**GE Hitachi Nuclear Energy**

MFN 07-645

Subject: **GE-Hitachi Nuclear Energy – Changes to ESBWR Design  
Control Document (DCD) Tier 1 Sections**

Summary of Changes to DCD Tier 1 Sections

Figure 2.2.1-1. Rod Control and Information System Control Logic Block Diagram

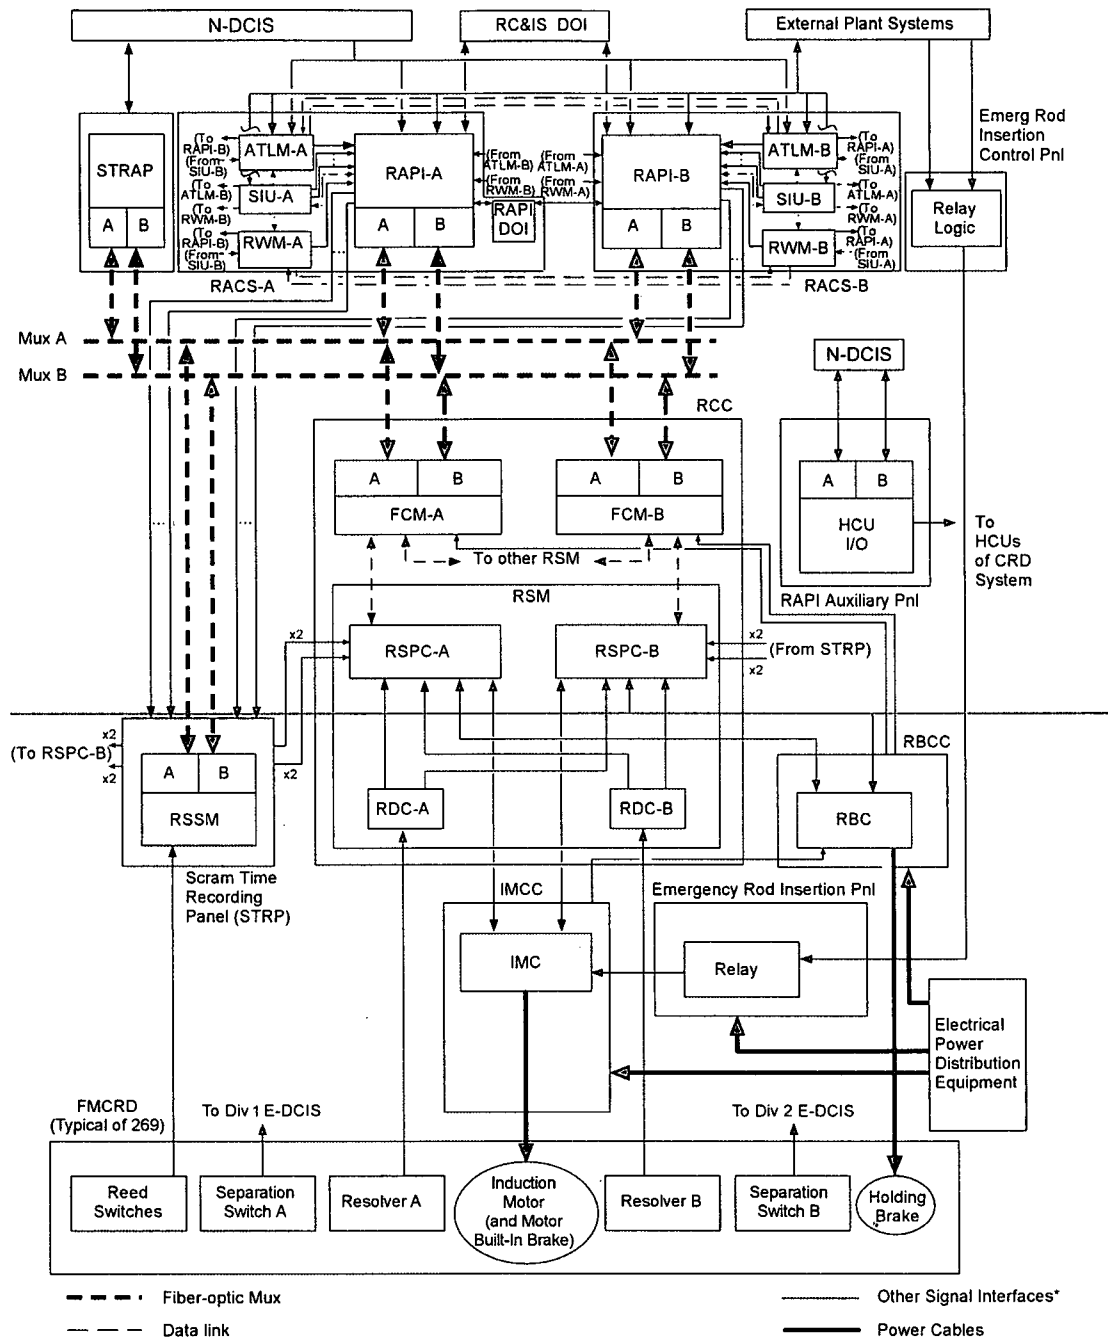
Item	Location	Description of Change
1.	T2.2.1-3	Add missing portion of Table 2.2.1-3.
2.	F2.2.1-1	Delete Figure 2.2.1-1. Figure is not referenced in the Design Description or the ITAAC.
3.	F2.2.3-1	Delete Figure 2.2.3-1. Figure is not referenced in the Design Description or the ITAAC.
4.	Table 2.2.5-3	Delete duplicate Table.
5.	Table 2.2.7-3	Delete word processing bracketed text.
6.	T2.2.12-2	Add missing portion of Table 2.2.12-2.
7.	S 2.2.13	Delete word processing bracketed text.
8.	S 2.2.14	Delete word processing bracketed text.
9.	T2.2.14-2	Delete the "SLC system initiation" Function.
10.	T2.4.1-3	Add missing ITAAC 25.
11.	F2.4.1-1.	Incorporate the appropriate Isolation Condenser System Schematic.
12.	T2.5.5-1	Add missing Design Commitment 6.
13.	S2.7.3	Add missing Item (3) a.
14.	S3.1	Separate Item 4 into Items 4, 5 and 6.
